Charlotte Historic District Commission Application for a Certificate of Appropriateness

December 8, 2010

ADDRESS OF PROPERTY 2100 Charlotte Drive, Dilworth Local Historic District HDC 2010-109

SUMMARY OF REQUEST Rear Hipped Roof Addition

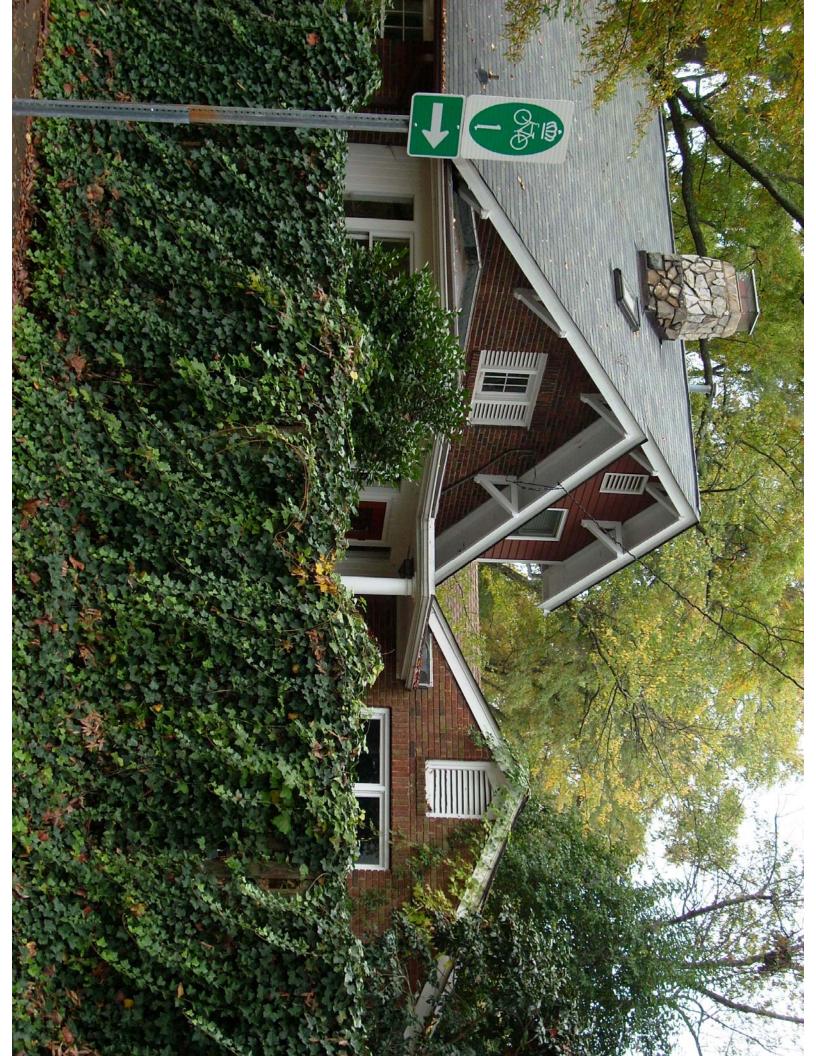
As shown on the attached plans, the proposed hipped roof section would replace the small flat roof on the rear of the house, on the corner of the house that faces Carling Avenue. The new roof hip as shown would span the entire rear of the main house.

The installation of this hip to address a leak problem on the porch roof would result in the elimination of the detailing in the rear gable of the house, including the deep eave, the decorative roof brackets, and the attic window and vent assembly. An increase in the slope of the existing roof would accomplish the same goal, and would allow for the preservation of these original architectural features.

The Commission's discussion focused on the appropriateness of the overall form of this proposed addition, since there is not at present a similar roof form on the house. There was also discussion on the detailing of some of the features, particularly the new rear columns. The HDC also stated that a full right elevation drawing would allow for a clearer review.

In response to the HDC's comments, the applicant has provided additional drawings for this project, which are attached. They appear to address all of the concerns raised by the Commission at the November meeting.
